CALIFORNIA COASTAL COMMISSION

STAFF REPORT: APPEALSUBSTANTIAL ISSUE

APPEAL NO.: **A-1-HUM-98-101**

PROJECT DESCRIPTION: A coastal development permit for a lot line adjustment between six parcels. (Parcel numbers involved: 301-191-60; 301-201-10/13; 301-221-05/06; 301-221-01; 301-161-01; and 302-161-02.) Parcel A will result in +/- 0.3 acres. Parcel B will result in +/- 0.7 acres. Parcel C will result in +/- 1.9 acres. Parcel D will result in +/- 3.0 acres. Parcel E will result in +/- 28.75 acres. (Note: Although the County Planning Commission approved the project as a multiple lot line adjustment, this type of project is more accurately characterized as a redivision because all six of the lots would be significantly reconfigured.)

EXHIBIT NO.	6
APPLICATION NO.	A-1-HUM-98-101
"BEFORE" PROJECT

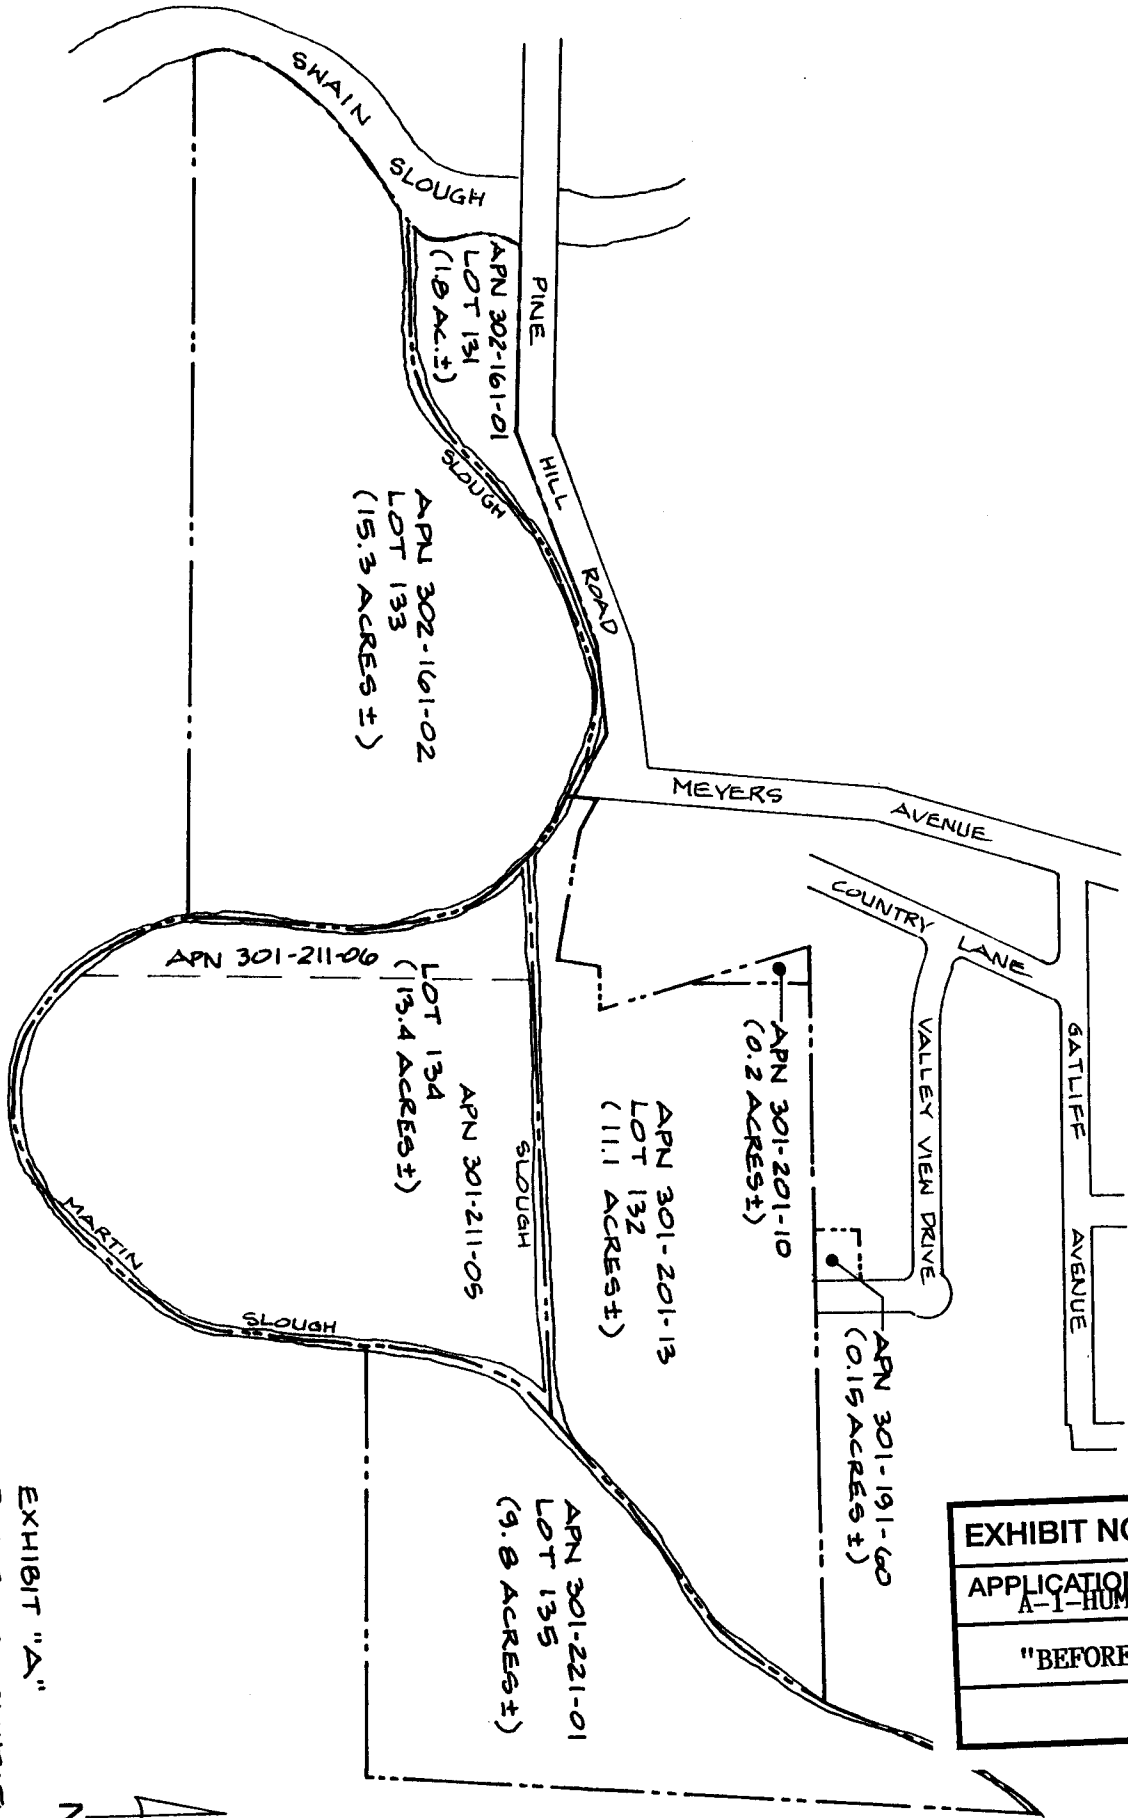
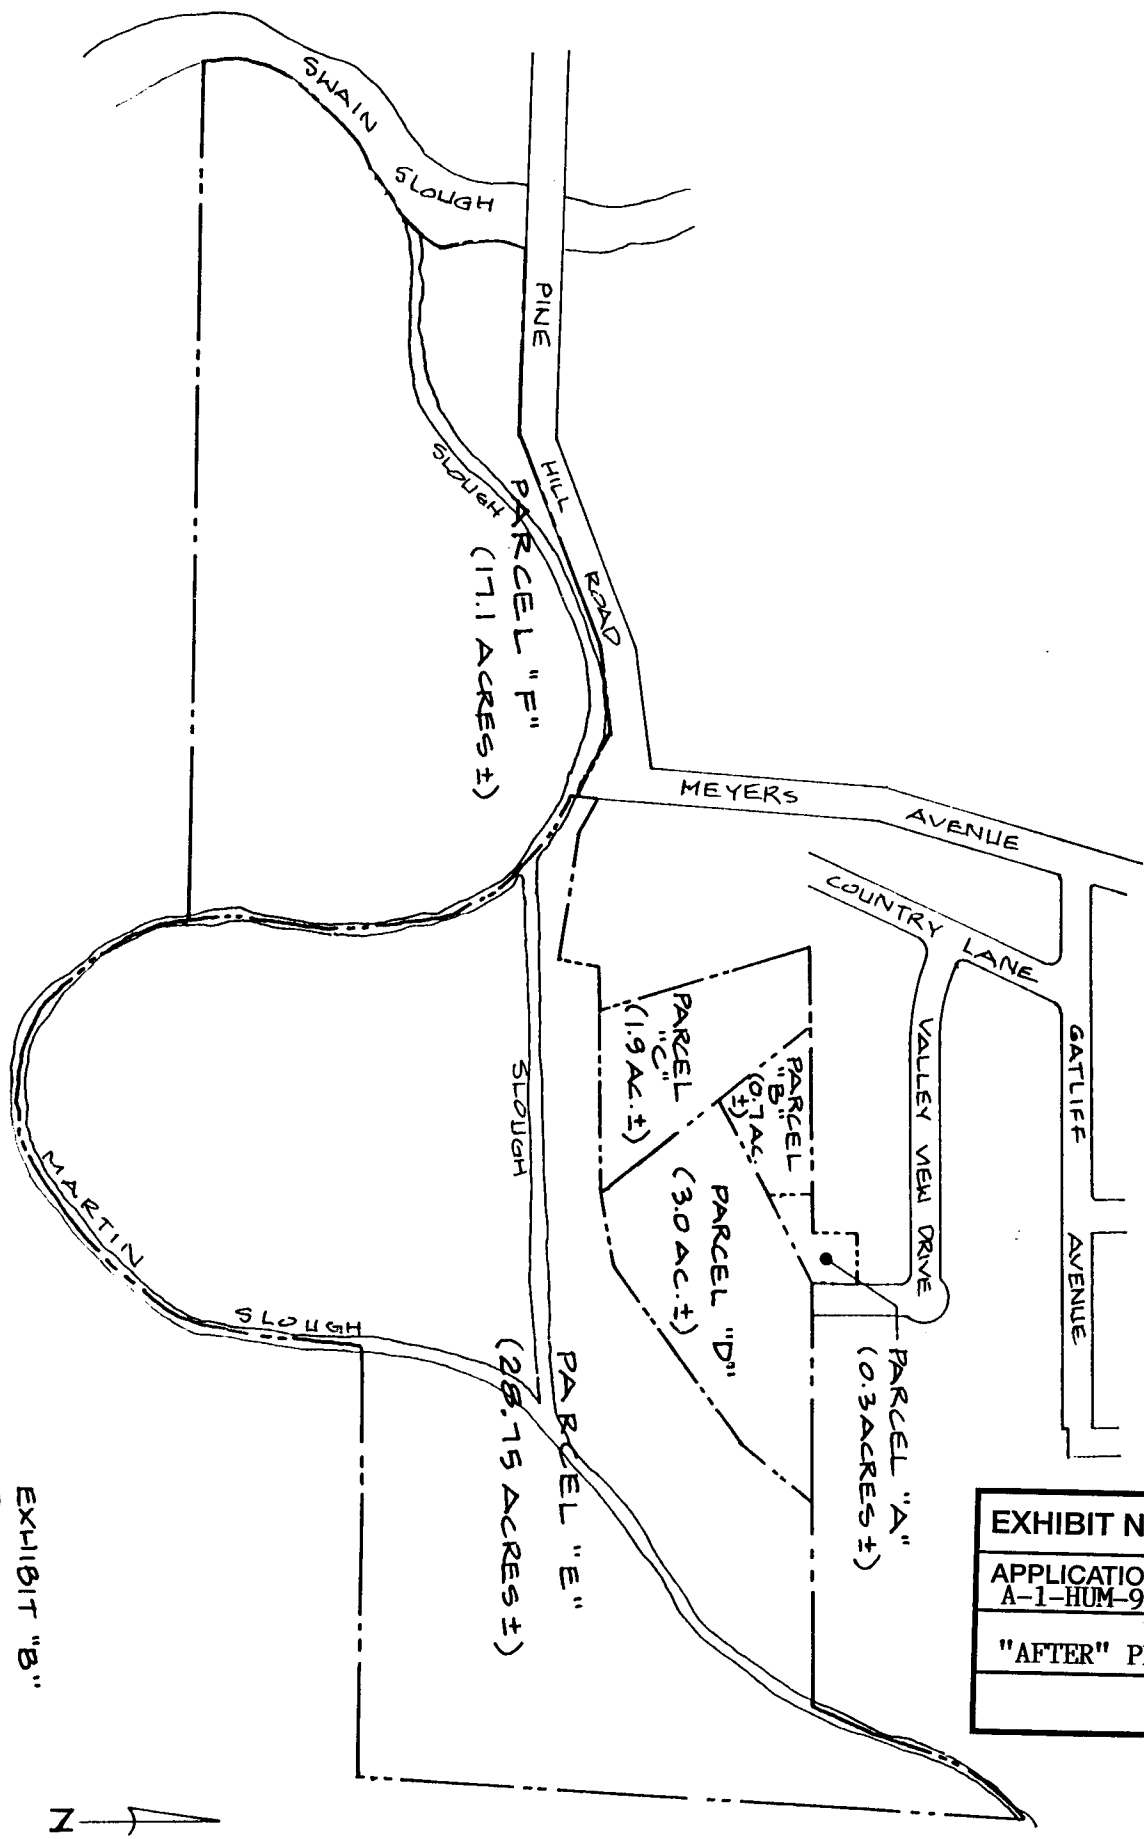
The appellant contends that the project is inconsistent with Policy 3.21(B)(2)(i), Rural Subdivision Requirements as the policy suggests the planned residential density for the area should be one unit/one acre and the reconfigured Parcel B is only 0.7 acres.

The project area is located at the southern end of a low-density residential development pattern that transitions into larger agricultural parcels at the subject property. The post-redivision residential parcel sizes of the subject property range from 0.3 acres to 1.9 acres or 13,068 square feet to 130,680 square feet. The gross average density of the reconfigured residential parcels would be one dwelling unit per 1.48 acres, greater than the minimum planned residential density called for in Policy 3.21(B)(2)(i) of one unit/one acre. Additionally, the project includes a requirement to convey to the County development rights for the low land agricultural parcels, Parcels E & F, for certain non-agricultural uses.

In addition, the project is consistent with the Residential/low density land use classification for the residential portion of the site. Chapter 4 of the Humboldt Bay Area Plan contains the Standards for the various land use plan classifications included in the plan area. More specifically, Chapter 4 defines the Residential/Low density (RL) land use classification to allow the development of detached single-family residences with a gross density of 3 to 7 units per acre. The reconfigured residential parcels more than double the minimum parcel size requirement for the RL land use classification.

All portions of the subject property with the Residential Low-Density Land Use Plan classification are currently zoned for Residential Low-Density, 5,000-sq. ft. minimum parcel size (RS-5). In fact, the parcel sizes in the adjacent subdivision range from 0.15 acres to 0.30 acres or 6,557 square feet to 13,417 square feet. All of the post-redivision parcel sizes meet or exceed the minimum parcel size requirement of the RS-5 zoning designation and the parcel size(s) within the adjacent subdivision. Thus, the Commission concludes that had the contention raised in the supplement to the appeal been submitted in a timely manner and could be considered as a valid grounds for an appeal, the contention would have raised no substantial issue with respect to conformance of the approved project with respect to Chapter the density requirements of Policy 3.21 (B)(2)(i) of the Humboldt Bay Area Plan.

FIGURE 3 (REVISED, 3-26-1998)
JOB 97-4656

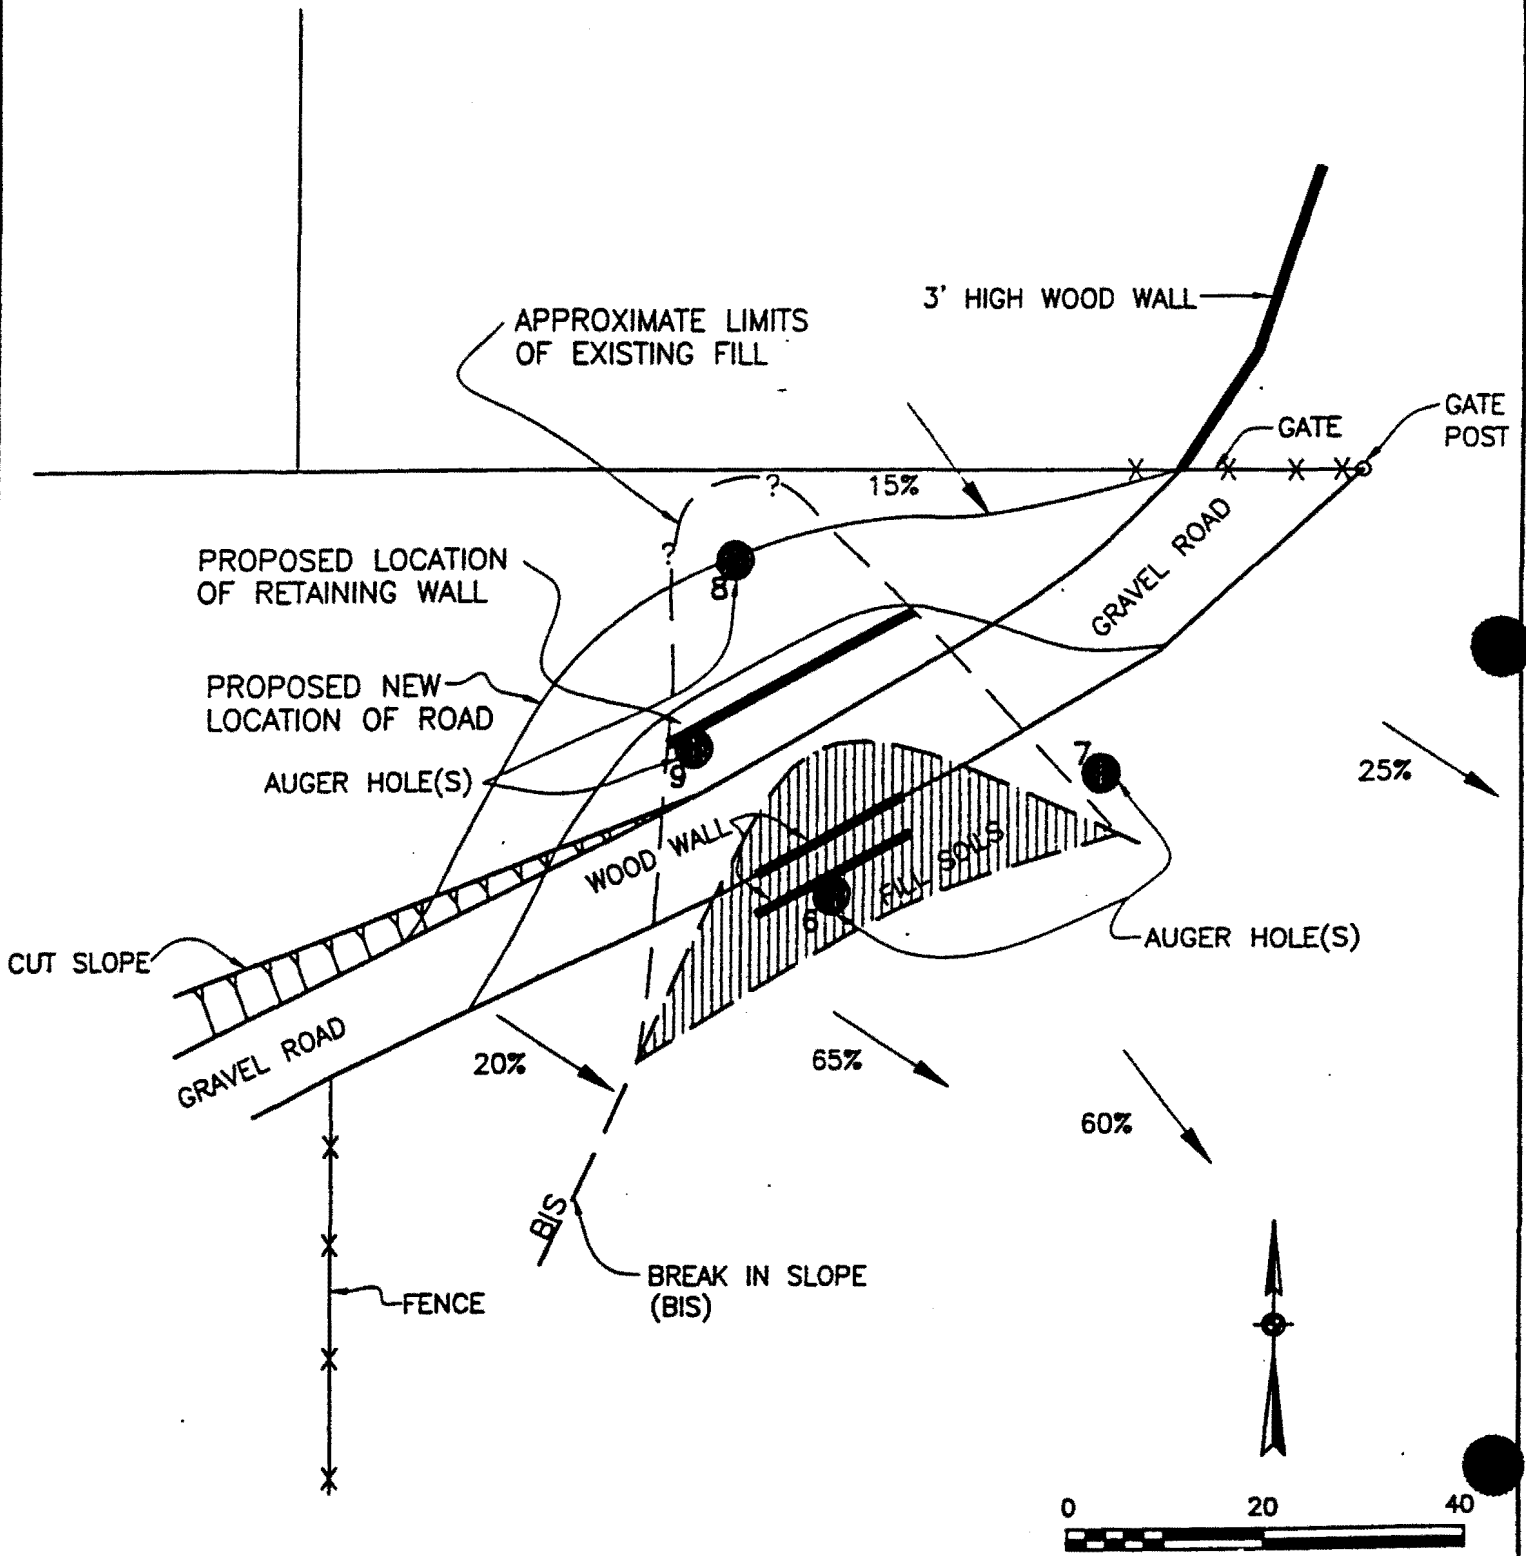
This letter report is an addendum to our previous report dated March 4, 1998. It presents recommendations for relocating and rebuilding a portion of the access road into the Senestraro site. The proposed new location of the access road is shown on Figure Three (revised).

On a recent site visit, we drilled two additional holes upslope of the existing road (Holes 8 and 9, see Figure 3, revised). These holes indicate that the fill prism extends farther upslope than we previously estimated. The fill in each of these holes is approximately three feet thick and underlain by approximately one to one and one-half feet of topsoil. The native subsoil in these two holes is a silty sand.

We recommend that a retaining structure be designed and constructed to support the portion of the road that traverses the head of the drainage. Because of the seasonally shallow water table at the site, any retaining structure should have an appropriate backdrain to avoid the buildup of hydrostatic stresses. To decrease the height and length of a retaining structure, and the size of the required excavation, we recommend that the road be moved upslope (see Figure Three, revised).

We recommend that the toe of a proposed Hilfiker Welded Wire wall be embedded a minimum of two feet into the native subsoil. The length of the primary mats for a Hilfiker Wall are approximately 0.7 times the height of the wall. Our preliminary calculations show that if the wall is built in the location as shown on Figure Three (revised), the height of the wall, including embedment at the toe, will be approximately seven feet. Thus, the cut for the primary mats will be approximately five feet. We recommend that the cut on the uphill side be no steeper than 1 ½:1.

Provide a means of drainage at the heel of the Hilfiker Welded Wire Wall. We recommend using four inch corrugated perforated plastic pipe with perforations down. The pipe should be wrapped in filter fabric, and have a minimum slope of 2%. Drain outlets should extend beyond the toe of the wall. Tightline the portion of the drain that will daylight. Protect the outlets from erosion by placing cobble or similar.

FIGURE 3
JOB 97-4656

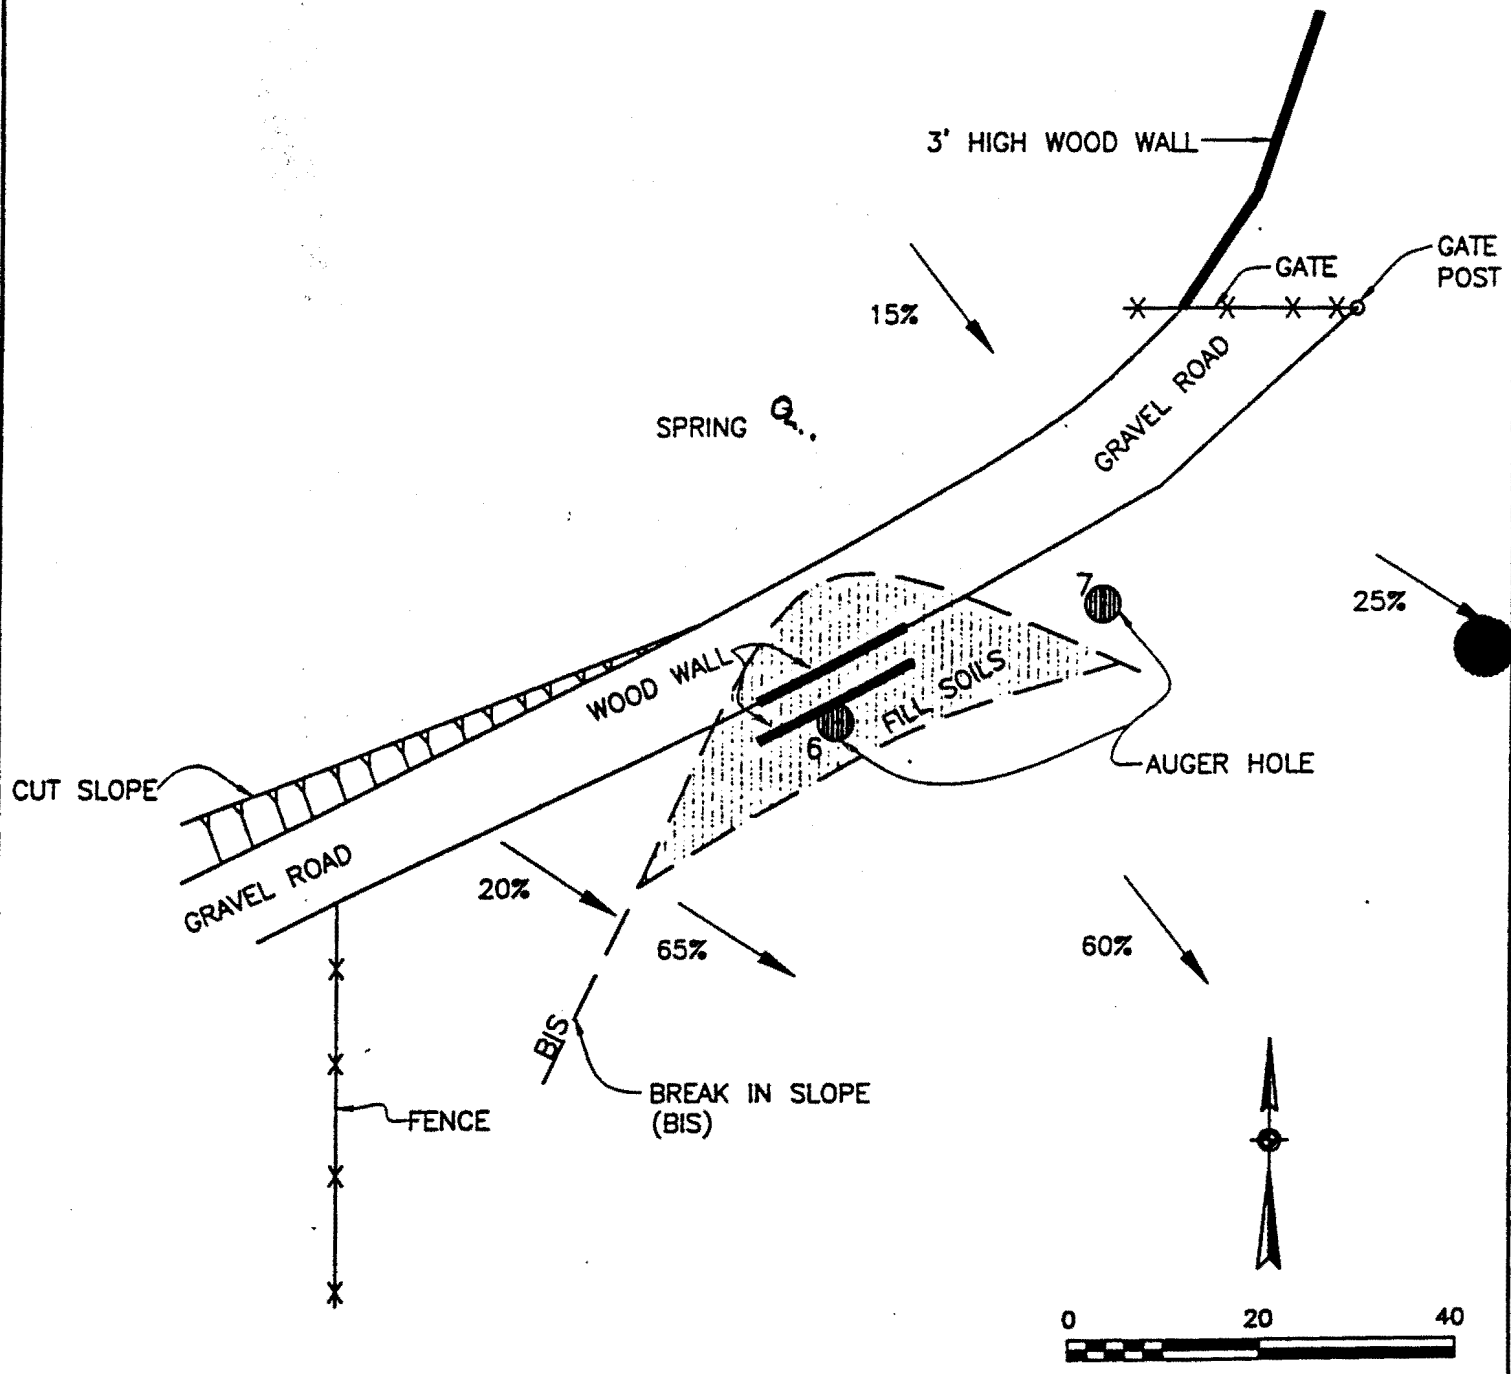
We estimate that there is approximately nine feet of soft, moist fill soils in a portion of the existing roadway that crosses a drainage head at the site (see Figure Three). The face of this fill prism is sloped at 65%. The buried native slope appears to have an approximately 50% slope steepness. The fill is underlain by topsoil. At the time of our visit, water was perched in the basal portion of the fill. We previously determined that this fill is unstable and recommended that the fill be retained, or the road be moved upslope to avoid the drainage head.

The fill in a portion the existing roadway (Figure 3) consists of a mixture of topsoil, subsoils, and woody debris. At the time of our visit, it was soft and wet. Beneath the fill is native topsoil (see appendix I). At the time of our visit, water was perched in the basal portion of the fill. In addition, there was an area of emergent groundwater slightly uphill from this fill prism.
